Addendum # 4

Dated: September 25, 2024

Bid Opportunity: T-24-33 - General Contractor for the Construction of a Helicopter Hangar and Related Interior and Exterior Spaces in the Town of East Gwillimbury, Ontario

Thermal Standing Seam Roof System: Hat and Chair Stand-off
Purlins at 2'-0" to 5'-0"

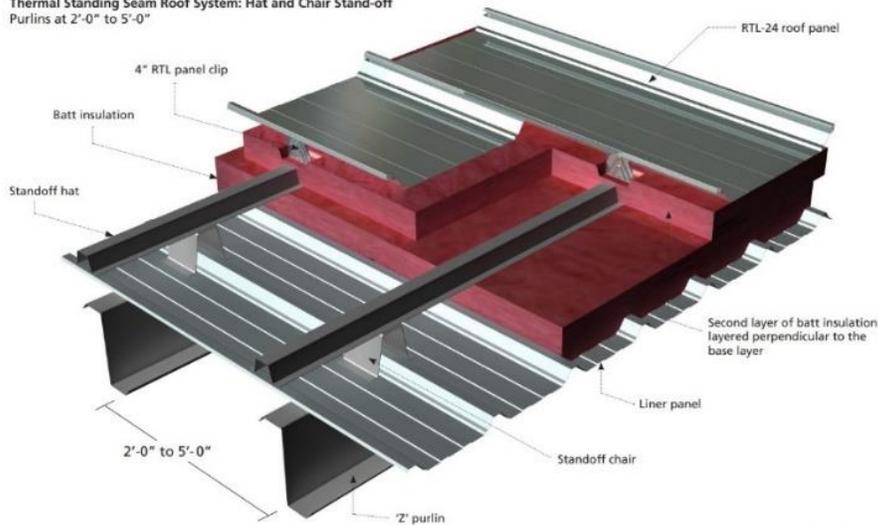
Re: Pre-eng building: Please confirm if Standing Seam Roof System: Hat and Chair Stand-off Purlins at 5'-0" is acceptable. How can we attach a cut sheet at Bids & Tenders for more information?

Sample info: Overall Insulation Thickness: 305mm, Chair Height: 203mm, Hat Height: 47.7mm, Effective R-Value: R-37.5, Highest Zone Meet w Ashrae 90.1-2013: 6A,6B. 3D Thermal modeling conducted by Morrison Hershfield using steel building components manufactured by Steelway Building Systems. Software validated as part of AHRAE Research Project 1365-RP.

Answer 131: Thermal Modelled Roof system by Steelway is acceptable subject to dimensions listed above and that all thermal blocks to minimize thermal loss are included to achieve thermal ratings as noted on detail below
